DATE RECEIVED	9/8/93	PERMIT NUMBER	ACT/015/025
Title of Proposal: POND 'C' AS BUILT		PERMIT CHANGE #	93M
Description: RESPONSE TO NOV N93-35-7-3		PERMITTEE	CO-OP MINING
		MINE NAME	BEAR CANYON

Re: Sediment Pond "C" As-Built, N93-35-7-3 part 1 or 3, Co-Op Mining Company, Bear Canyon Mine, ACT/015/025, Emery County, Utah

TO: Pamela Grubaugh-Littig, Permit Supervisor
FROM: Jess Kelley, Reclamation Engineer *JK*
RE: Field Verification of As-Built Drawing of Sediment Pond C Submitted in Response to Violation N93-35-7-3, Part 1, Co-Op Mining Company, Bear Canyon Mine, ACT/015/025-93M, Folder #2, Emery County, Utah

POND C

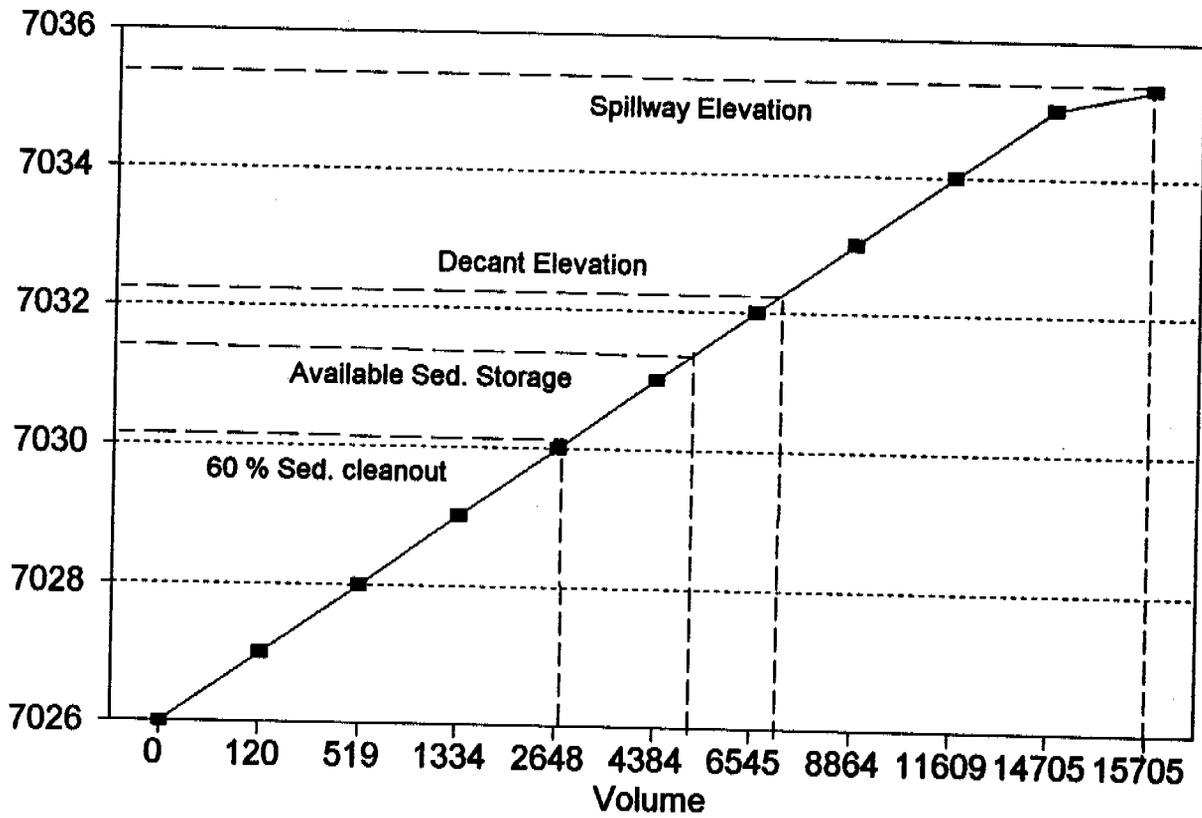
The following calculations are based on the ~~proposed as-built~~ pond geometry shown on Plate 7-6. ~~Upon completion an as-built survey will be made and compared to the proposed geometry.~~

The storm runoff volume from the 10-yr 24-hr storm event is 7,881 cu ft (0.181 acre-ft). The computation of the runoff volume assumed a curve number of 90 for the disturbed areas, 100 for the pond area. ~~Assuming the pond fully contains this runoff volume,~~ the decant elevation is 7032.3 ft., ~~allowing for a water storage volume of 10,423 cu ft.~~ The 60 pct sediment clean out level is at an elevation of 7030.3 ft, 2 ft below the decant elevation. The sediment storage volume at the 60 pct clean out level is ~~10703,169~~ cu ft. The maximum sediment storage volume is ~~17825,282~~ cu ft, located at an elevation of 7031.4 ft. With an estimated annual sediment volume of 126 cu ft, ~~the sediment level would reach the 60 pct cleanout level in approximately 25 years,~~ ~~the proposed pond design will provide many years of sediment storage. This scenario is proposed since it will allow for a greater sediment storage and less frequent maintenance.~~

Computations were conducted assuming that the pond contained the maximum sediment volume. It was further assumed that the pond was full of water up to the ~~emergency~~ spillway flowline prior to the start of the design runoff event. This results in a conservative estimation of the maximum stage since, in general, the pond can be assumed to be empty to the decant elevation at the beginning of a storm event. The ~~proposed~~~~constructed~~ pond C will adequately pass the 25-yr, 6-hr peak flow.

Maximum volume below the emergency spillway is 15,705 cubic feet. The required volume for the 10 year - 24 hour storm event is 8,511 cubic feet. Therefore, the structure will contain the required storm event.
